Date of Issue: September 2019

Affected Publication: ANSI/API Specification 17D/ISO 13628-4, *Design and Operation of Subsea Production Systems—Subsea Wellhead and Tree Equipment*, Second Edition, May 2011

Errata 8

Table 11 — Hub Dimensions for Type 17 SV Flanges – USC Units

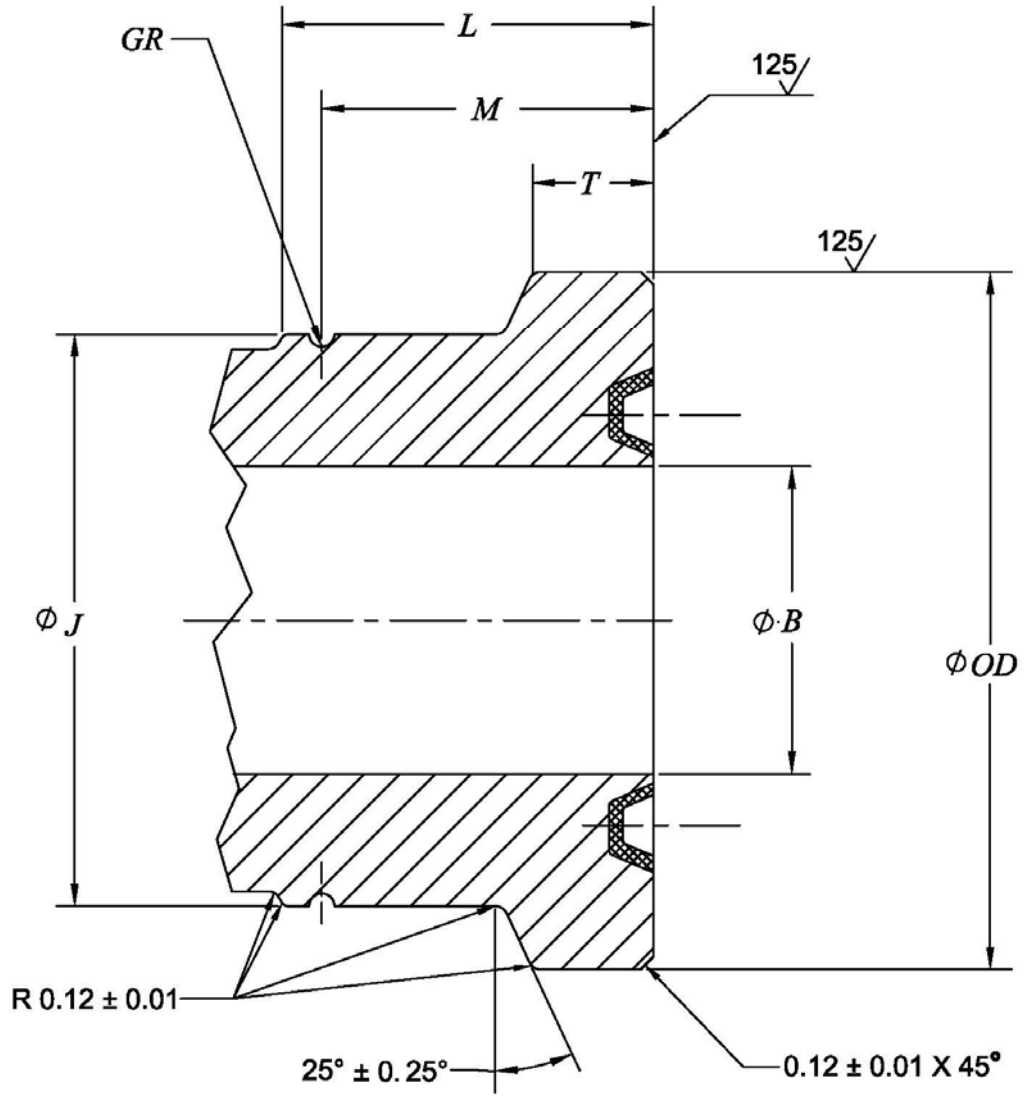
Replace Tables 11, 12, 13 and 14 with the following Tables 11, 12, 13 and 14.

Dimensions in red are corrected values or additional data previously omitted in error.

Hub dimensions for 17SV flanges for 5000 psi rated working pressure — USC units

Nominal size (in)	Maximum Bore	Outside diameter	Total thickness	Large diameter of neck	Length of neck	Groove location	Retainer groove radius	Ring groove
	<i>B</i>	<i>OD</i>	<i>T</i>	<i>J</i>	<i>L</i>	<i>M</i>	<i>GR</i>	
Tolerance:	maximum	± 0.03	+ 0.03/ -0	+ 0.03/ -0	minimum	+0.030/-0	+0.005/-0	
2 1/16	2.09	5.03	1.17	3.66	3.28	2.907	0.125	BX-152
2 9/16	2.59	5.78	1.17	4.41	3.28	2.907	0.125	BX-153
3 1/16	3.09	6.31	1.17	4.94	3.43	3.067	0.125	BX-154
4 1/16	4.09	7.62	1.20	6.25	3.76	3.382	0.125	BX-155
5 1/8	5.16	9.38	1.41	7.75	4.73	4.357	0.125	BX-169
7-1/16	7.09	10.70	1.62	9.07	5.54	4.979	0.188	BX-156
9	9.03	13.25	1.62	11.62	6.11	5.551	0.188	BX-157
11	11.03	16.25	1.65	14.62	6.93	6.370	0.188	BX-158
13 5/8	13.66	20.62	1.87	19.00	7.15	6.614	0.188	BX-160

Hub dimensions for 17SV flanges for 10,000 psi rated working pressure — USC units

Nominal size (in)	Maximum Bore	Outside diameter	Total thickness	Large diameter of neck	Length of neck	Groove location	Retainer groove radius	Ring groove
	<i>B</i>	<i>OD</i>	<i>T</i>	<i>J</i>	<i>L</i>	<i>M</i>	<i>GR</i>	
Tolerance:	maximum	± 0.03	+ 0.031/-0	+ 0.03/-0	minimum	+ 0.03/-0	+0.005/ -0	
1 13/16	1.84	4.50	1.166	3.250	3.282	2.907	0.125	BX-151
2 1/16	2.09	5.00	1.166	3.750	3.282	2.907	0.125	BX-152
2 9/16	2.59	5.80	1.166	4.550	3.302	2.927	0.125	BX-153
3 1/16	3.09	6.93	1.197	5.680	3.666	3.291	0.125	BX-154
4 1/16	4.09	8.44	1.310	6.812	4.277	3.902	0.125	BX-155
5 1/8	5.16	9.96	1.500	8.335	4.732	4.357	0.125	BX-169
7-1/16	7.09	13.66	1.653	12.035	6.204	5.641	0.188	BX-156
9	9.03	16.25	1.653	14.625	7.270	6.707	0.188	BX-157
11	11.03	18.87	2.035	17.245	8.153	7.591	0.188	BX-158
13 5/8	13.66	22.25	2.309	20.625	9.531	8.969	0.188	BX-159
